Yandicoogina Iron Ore Project – Revised Proposal

Response to Submissions

State Assessment Number: Assessment No. 2017

Prepared for Rio Tinto by Eco Logical Australia

Figure A1
Riparian zones
and location of
dominant tree strata

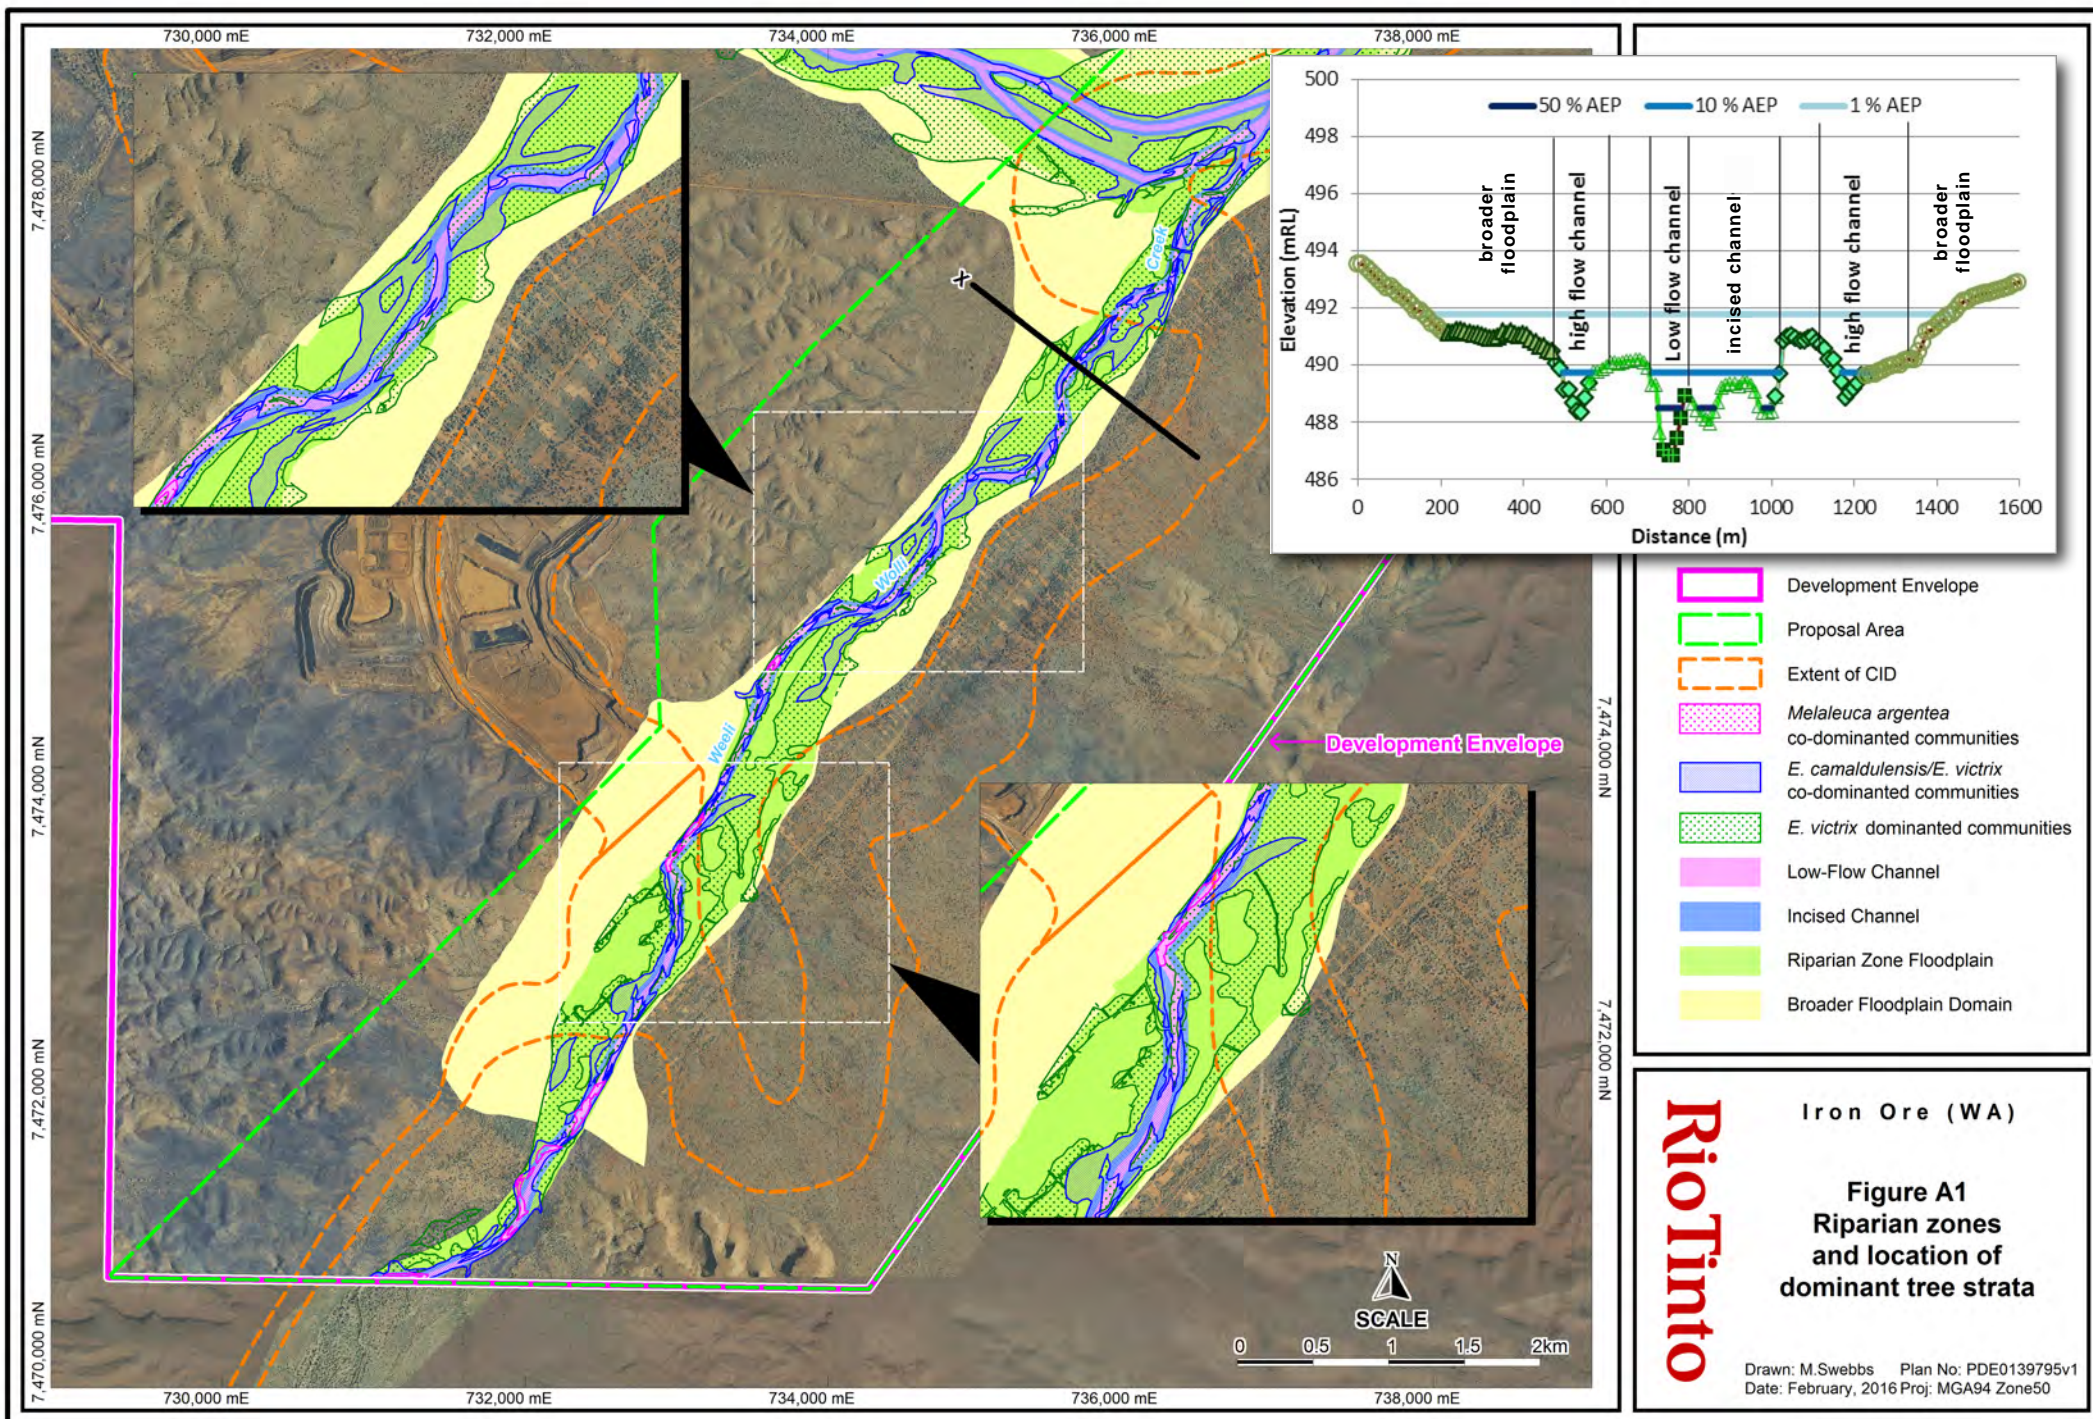
Issue no.	Submitter	Submission and/or issue	Proponent response
			<p>broader floodplain (where <i>M. argentea</i> does not occur, but <i>Eucalyptus camaldulensis</i> will occur).</p> <p>In relation to (1) the incised-channel/low-flow zone and adjacent banks: During groundwater abstraction and subsequent drawdown, depth to groundwater is considered inconsequential given the ongoing approved surplus water discharge expected to be maintained within the Proposal Area. This discharge is predicted to augment alluvial sediment moisture levels, and as a result, adequate soil-pore moisture in the fringing areas should remain to support the ongoing persistence of riparian vegetation. Alluvial saturation zones, and associated soil pore water in the adjacent capillary fringes may change and become more spatially variable; however, in the upper sediments where moisture presence is most important, adequate soil pore water will likely be maintained, and therefore riparian vegetation should not be subject to unusually high degrees of water stress from groundwater drawdown.</p> <p>A good example for comparison is the development of below water table open cut mine pits adjacent to riparian vegetation communities in the existing Yandi operations. Plate 4 of the PER document and Plate 3 of Rio Tinto (2016a) provide a visual indication from October 2015 of the proximity of riparian vegetation located in the incised channel zone of Marillana Creek adjacent (approximately 50 m) to the existing JSW pit wall. Populations of <i>M. argentea</i> (including mature baseline populations), along with vegetation comprising this species as a structural component continue to exist in this area without an observable impact from drawdown associated with the existing mining operations. With the water table beyond the reach of such highly soil water dependant populations, their persistence is inferred as being supported by the saturated alluvials and adjacent pore water of the capillary fringe provided by the perennial surface water regime.</p> <p>In relation to (2) the floodplain zone: The majority of this zone occurs outside the area of expected influence from surplus water discharge. There may be some potential for impact from a rapid decline in the groundwater table as a result of drawdown in this zone. The ongoing surplus water discharge since 2007 from Hope</p>

Figure A6
Modelled groundwater
drawdown as a result
of the Proposal at
the year 2032

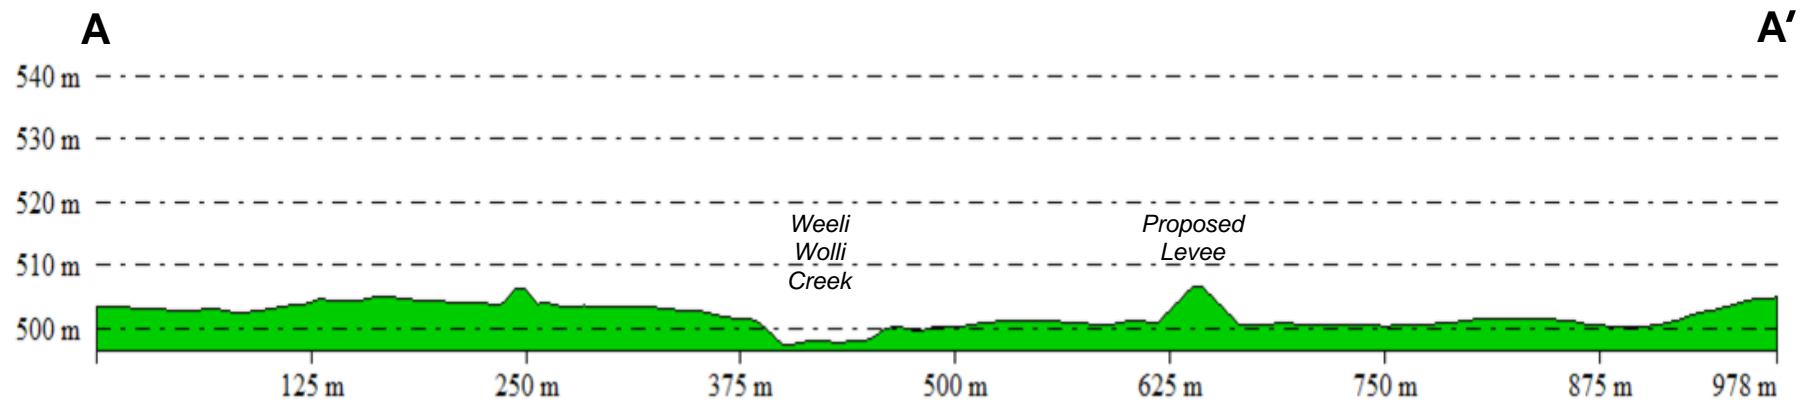
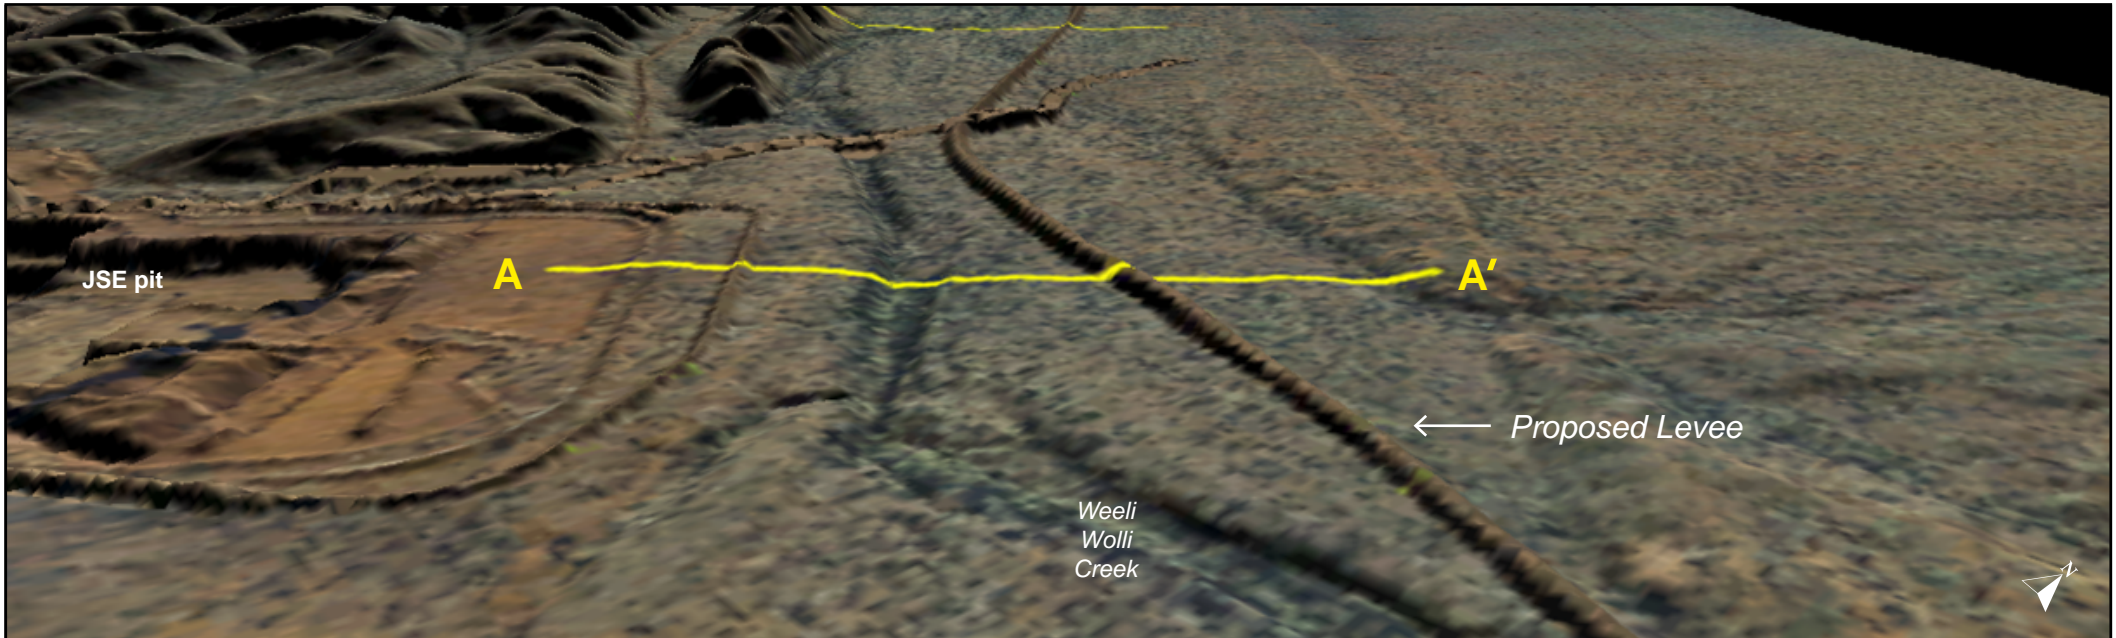
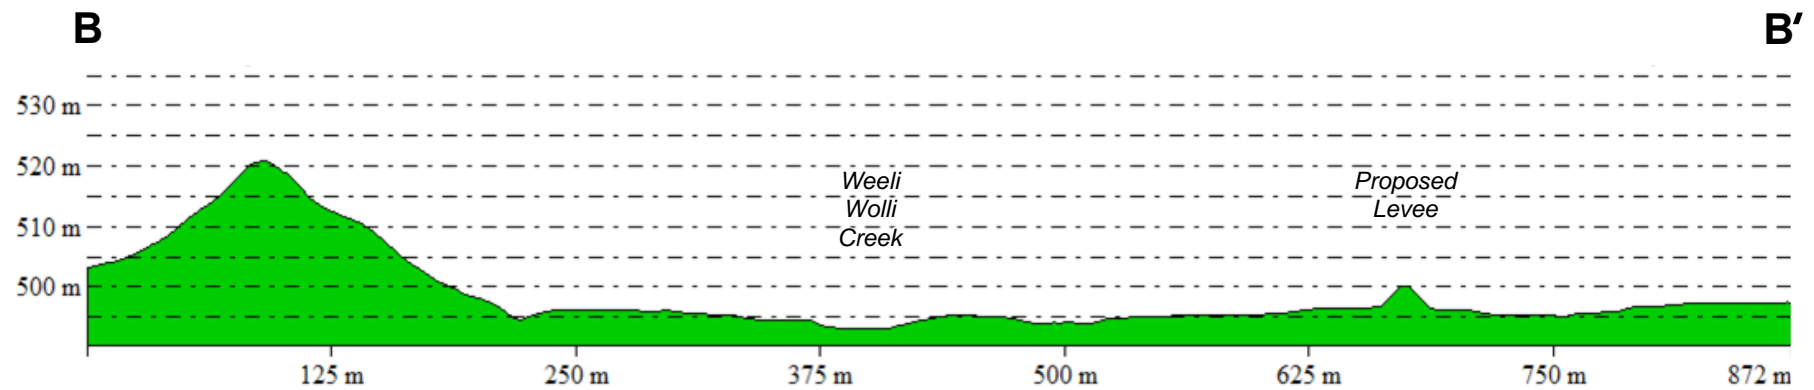
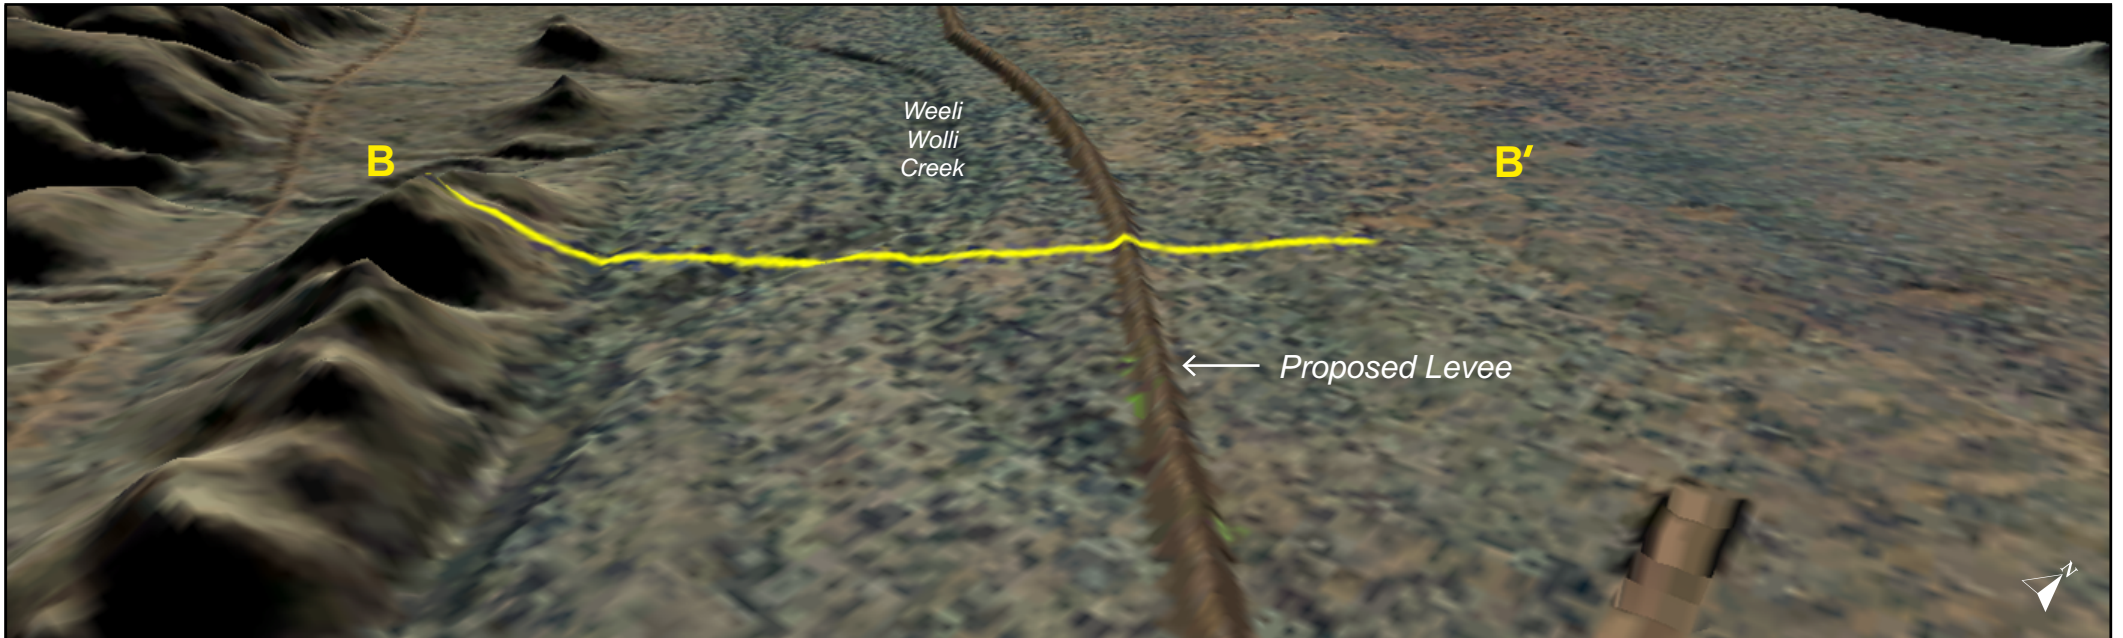
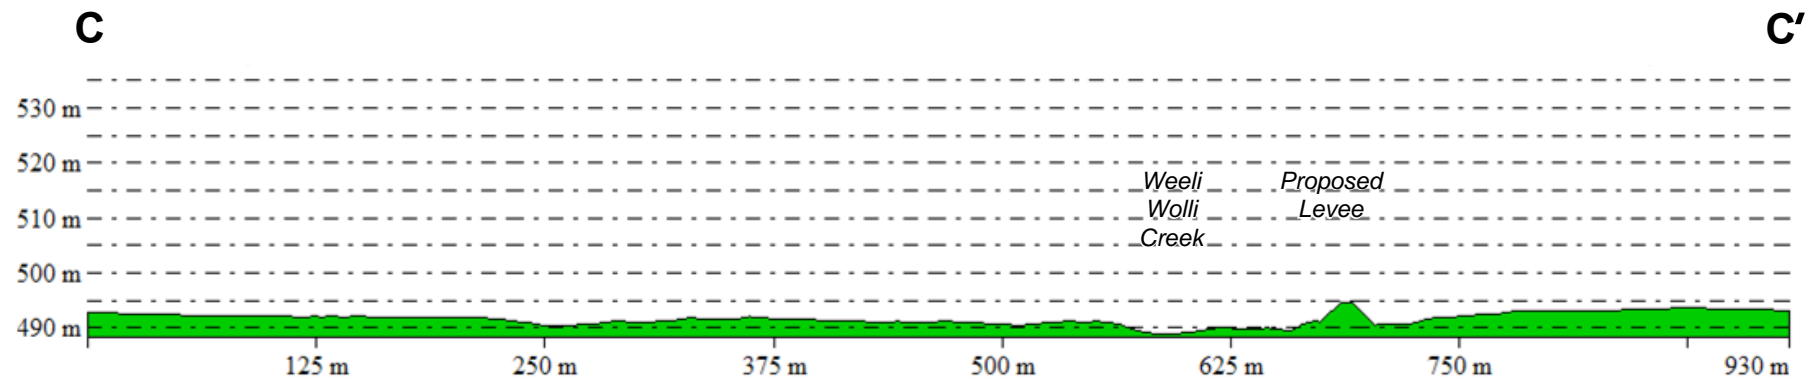
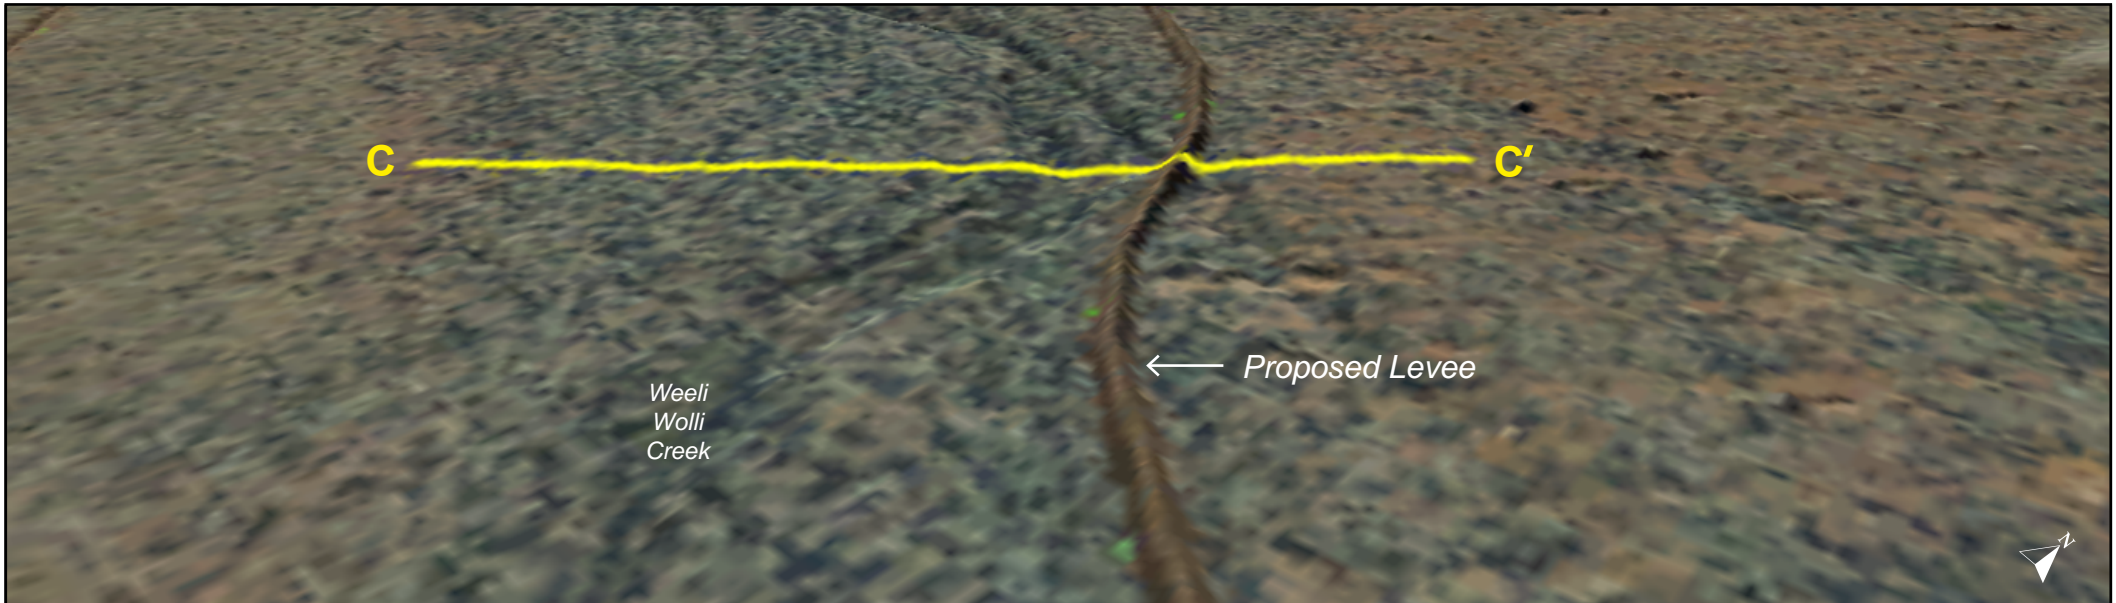
Issue no.	Submitter	Submission and/or issue	Proponent response
			as a result of the cumulative discharge from the Hope Downs 1 (Rio Tinto), Yandicoogina (Rio Tinto) and Yandi (BHP Billiton) mine operations.
11	DoW	<p>Simulated drawdown maps appear to indicate some impacts to groundwater levels at the northern boundary of the model. Considering this, provide a discussion to confirm that no impacts to Fortescue Marsh will occur.</p>	<p>Discharge from D09 has been included in the model, which contributes to the sharp boundary change in the northern part of the model domain near the confluence of Marillana Creek and Weeli Wolli Creek.</p> <p>Simulated drawdown at the northern boundary of the model is less than 1 m (Figure A6; Appendix A of this document). On this basis, the potential for impact to Fortescue Marsh, located approximately 30 km from the northern boundary of the model, is considered negligible.</p> <p>Refer also to the Proponent response to Issue No. 10, which discusses the problems posed by potential inclusion of the Fortescue Marsh in the model domain, along with the key results of studies (Dogramaci et al. 2012, Skrzypek et al. 2013, Dogramaci and Skrzypek 2015, Dogramaci et al. 2015, Rio Tinto 2016c [Appendix B]) undertaken to address the potential effect of the proposed dewatering on the water balance of the Marsh.</p>
